**Dunedin City Council – RM20.280 Hearing for proposed operation of a landfill at Smooth Hill May 2022**

Applicant expert witnesses' comments made at the Hearing in response to issues raised in submitters evidence

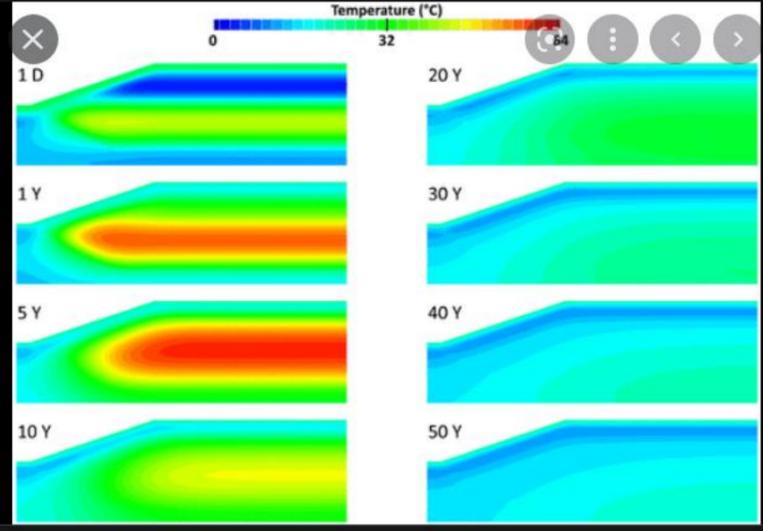
<b>HDPE Geomembrane Liners (life expectancy)</b>	Andrew Rumsby	46 – 64	<ul style="list-style-type: none"> <li>The risk management procedure should leachate seep from a perforated HDPE liner, provides for leachate detection and collection in the groundwater drainage system under the landfill liner, and to pump the contaminated groundwater to the leachate system for disposal off site.</li> <li>To put context to the feasibility of collection and disposal of contaminated groundwater as leachate; the leachate flow expected at closure is 46,000m<sup>3</sup>/A and the groundwater flow is 69m<sup>3</sup>/A. i.e. a further 0.2% added to the leachate volumes and has little effect to the daily leachate volumes.</li> <li>Leachate composition changes over time to become significantly less concentrated as the organics in the waste are digested. The UK Dept of Environment suggested that in 60 years, the leachate is practically inert (Copied from <i>A Guide for the Management of Closing and Closed Landfills in New Zealand</i>). Once the leachate is inert, there is less reliance on the competence of the landfill liner system for retaining leachate</li> </ul>

Submitter issue	Submitter	Reference	Mr Richard Coombe response
			<div data-bbox="1210 384 1991 884" data-label="Figure"> </div> <p data-bbox="1210 894 1941 940"><b>Figure 3.1:</b> Changes in composition of leachate Source: Modified Figure C.4 from UK Department of the Environment, Waste Management Paper No. 26B, 1996.</p> <ul data-bbox="1210 1003 2635 1713" style="list-style-type: none"> <li>• Any losses through the HDPE is also restricted through the GCL and the 600mm clay liner laid beneath the HDPE and will not degrade as HDPE will.</li> <li>• I covered HDPE liner life in my main evidence. I agree with Mr Rumsby that the HDPE liner will deteriorate before the theoretical HDPE life of 400 years.</li> <li>• P.70 of my evidence stated the HDPE would last to 400 years <b>under ideal conditions</b>. I stand by this but point out I also discussed that there are number of factors that reduce the life of the liner. These factors are the same as those discussed by Mr Rumsby</li> <li>• The aging of the HDPE is as Mr Rumsby says; related in part to landfill temperature. This in turn is related to the biological and methanogenic phase of waste degradation that in itself is affected by temperature. Economic landfill gas extraction is expected to be viable for around 10 years after the fresh waste is applied to the landfill implying that the waste is less reactive and produces less heat after 10 years.</li> <li>• Temperature is developed in landfills in part by the biological breakdown of putrescible waste and the removal of this waste from the waste stream will reduce the heat developed in the landfill waste mass.</li> <li>• The removal of a significant portion of the putrescibles (in the forms of kitchen scraps) from the waste stream will reduce the biological action and temperature that would otherwise be generated by the breakdown of that kitchen waste.</li> <li>• The higher temperatures developed in landfills are more in the centre of the waste than the sides that contact the HDPE liner</li> <li>• This is supported by the modelling by Kunar Kopp et al (2021) where the following figure shows the location and period of heat generation in a landfill</li> </ul>

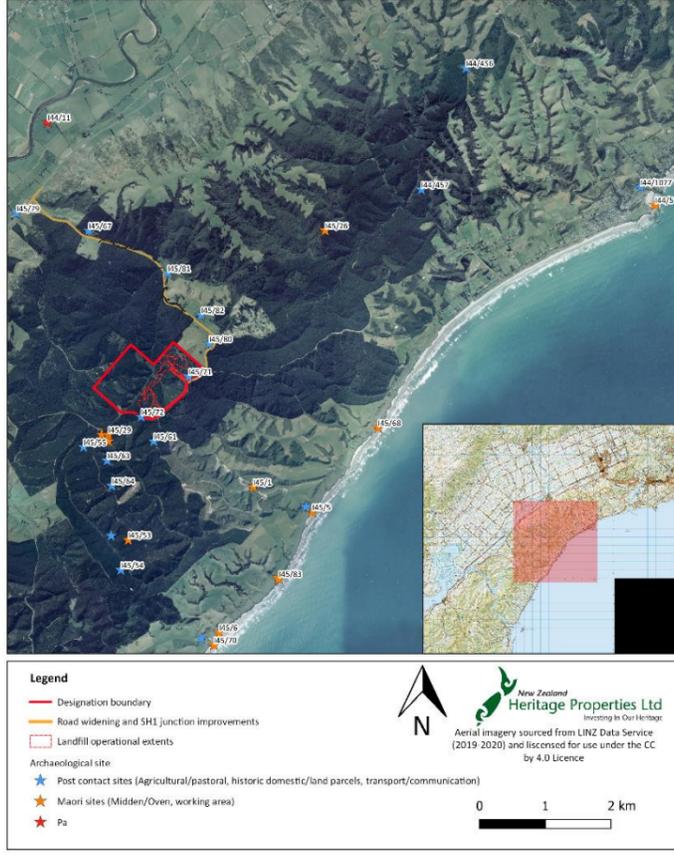
Submitter issue	Submitter	Ms Megan Lawrence response
<p>No consideration to the cultural and archaeological significance of the Ōtokia landscape</p>	<p>Anne Mauger</p>	<ul style="list-style-type: none"> <li>• Through desktop research and a site survey, my assessment considered the potential for physical archaeological remains (relating to both mana whenua and Pākehā activity) to be present within the project area.</li> <li>• I assessed effects to archaeological sites for which there is evidence for physical remains to be present.</li> <li>• No archaeological sites relating to mana whenua occupation have been recorded within the project area.</li> <li>• There is potential that unrecorded archaeological remains associated with mana whenua activity may be encountered during works. This is to be managed through the archaeological authority process.</li> <li>• I have provided the new map (Fig 2) below as an alternative archaeological site map to that provided by Anne Mauger.</li> <li>• Figure 2 distinguishes between sites relating to mana whenua occupation and those recording post contact farm, transport, and domestic sites. It also shows the sites in relation to the project area to provide perspective on potential effects of the proposed works on these sites.</li> </ul>  <p>Figure 2: Archaeological sites (tabled at the Hearing 17 May 2022)</p>
